CITY COUNCIL STAFF REPORT - SUMMATION

Sweetgrass PUD Final Plan

PROJECT: Sweetgrass PUD Development Master Plan

WORK DESCRIPTIONS: A regulating plan for the Sweetgrass Planned Unit Development (PUD) master planned community.

Figure 6 – Staff-recommended Greenway Route for the Master Trails Plan
Source: Landmark Engineering LTD

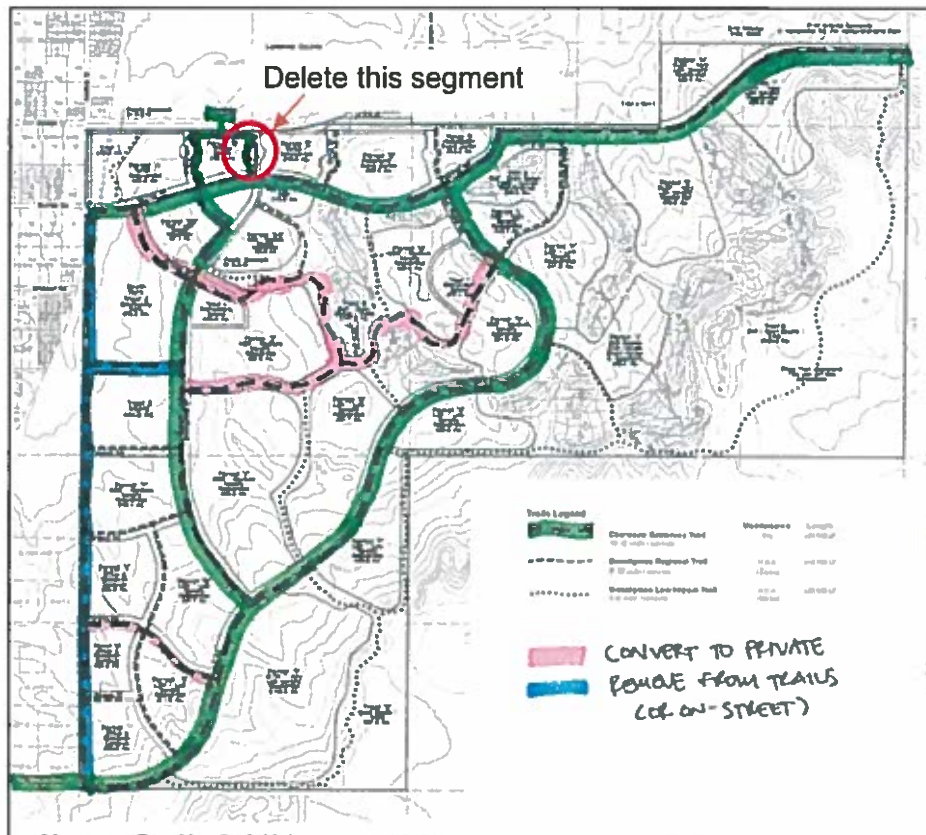
The revised Master Trails Plan, submitted on April 23, 2018, does not reflect the greenway route and alignment recommended by staff after review of the first submittal. Figure 6 below and Attachment C to this staff report shows the greenway route in green highlight with the exception of a segment abutting the Parcel B Village Center block which should be shorted to exclude the segment that begins at the proposed LCCC tunnel entrance and leads eastward to Sweetgrass Drive and then moves south to Murray Road because this segment is a redundant segment. The greenway route from the tunnel to the west to Goodnight Trail and then south to Murray Road is a more direct linkage to other greenway segments throughout the community. Lastly, due to the 12- to 15-foot change in elevation from where the tunnel exits under College Drive and the grade of the Sweetgrass land, the cost of building an ADA-compliant ramp to Sweetgrass Drive with safe slopes would be excessive for the Greenway Program's budget. Since it is costly and redundant, the City would seek to remove this segment from the Master Trails Plan Map as a City Greenway segment. This revision is recommended as Condition Number 1. Of course, the trail segment may remain as a private trail, but the City does not want it as a City dedication.

According to previous planning project Fox Farm Plan, there needs to be a Greenway (GW) along the East College Drive alignment that heads eastward. This could be accomplished by extending GW on Murray to where it intersects with Lummis. Also, the Sweetwater GW should extend to the future 4-legged intersection of College, College, Lummis and High Plains. The recently approved SE Greenway Trails connector plan shows a conceptual GW heading south along College to LCCC. Both these alignments were shown on past iterations of Sweetgrass Master Trail Plans.

According to the Applicant's engineer, the eastern portion of the greenway connecting to the College Rd. tunnel from LCCC has a significant elevation change requiring steps. This does not meet ADA requirements and, therefore, cannot be included as a segment of the City's greenway trail. Therefore, the segment of trail on the final plat from the tunnel eastward to Sweetgrass Drive and south to Murray, if retained, must remain private and not greenway. [see Condition No. 1.]

1. The Applicant shall amend the Sheet 6 PUD Master Trail Plan Map to reflect the greenway routes/alignment approved by the City's Community Recreation and Events Department.

Trails Legend

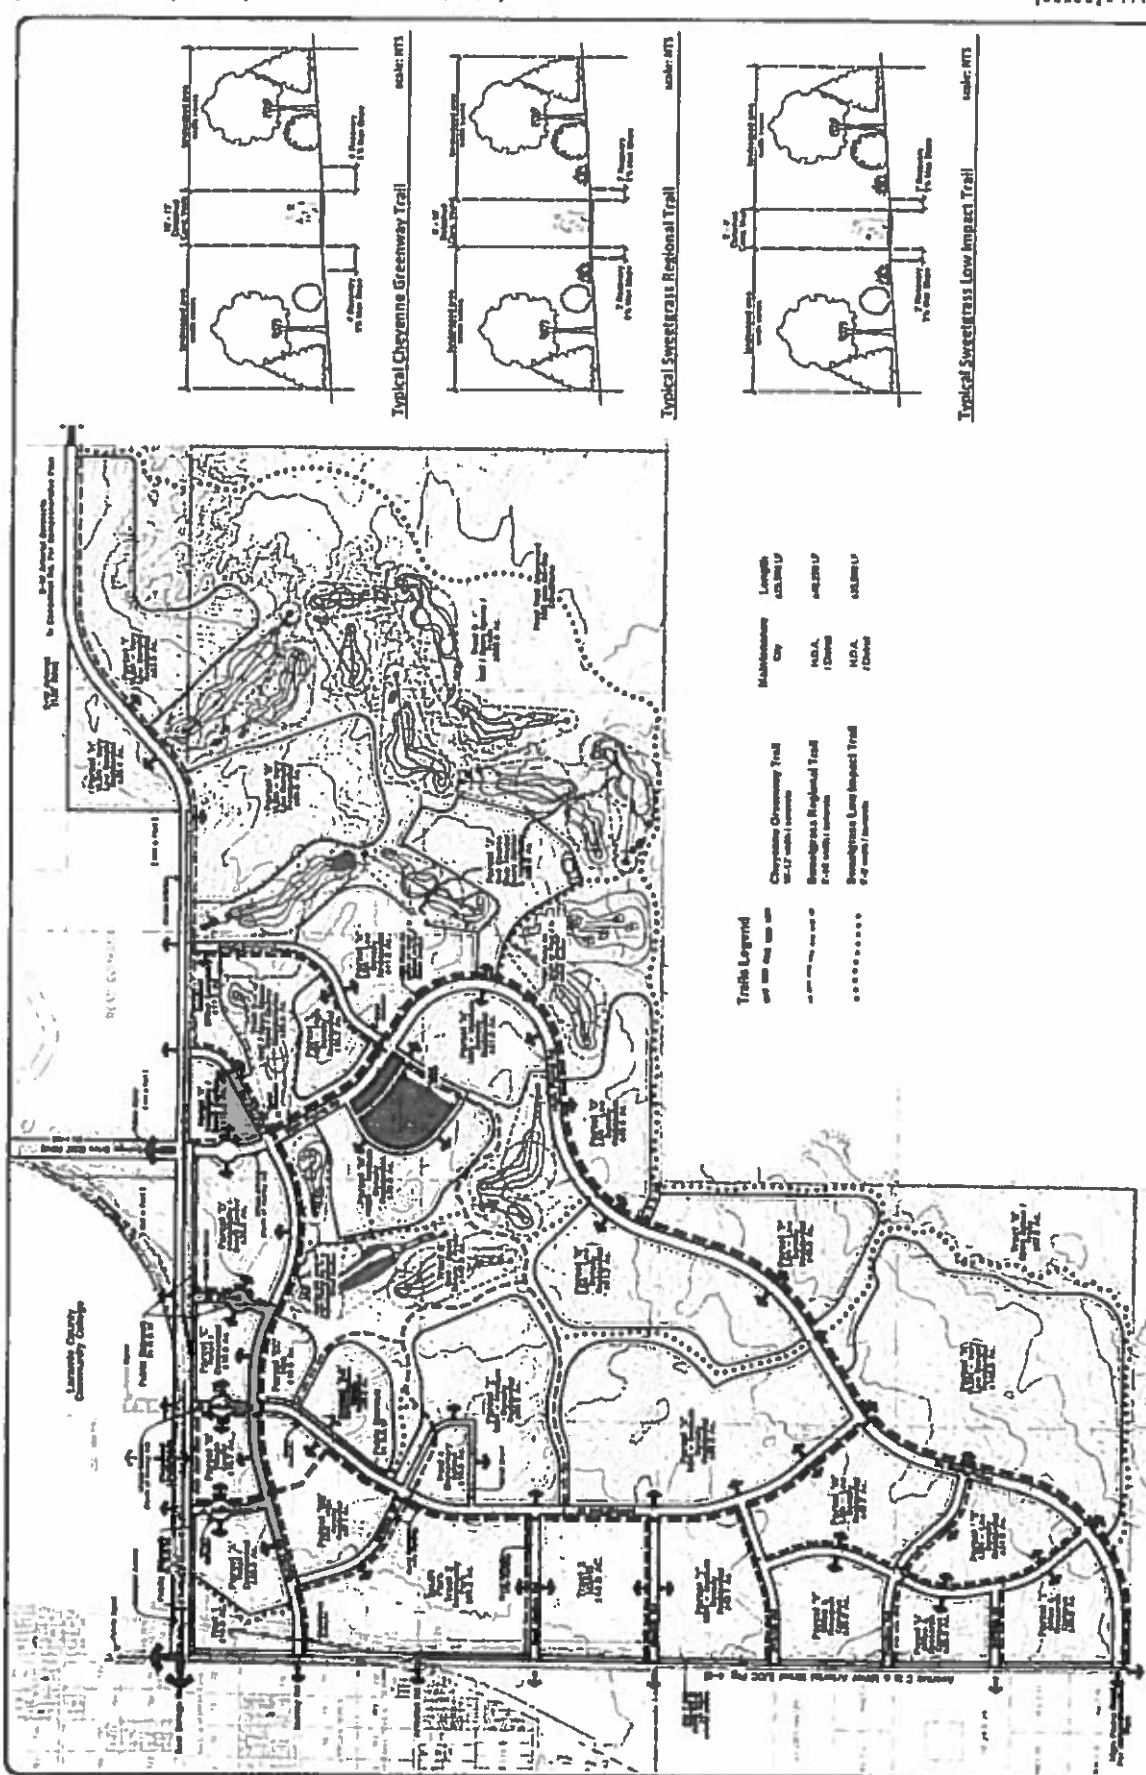
1. The Applicant shall amend the Sheet 6 PUD Master Trail Plan Map to reflect the greenway routes/alignment approved by the City's Community Recreation and Events Department.
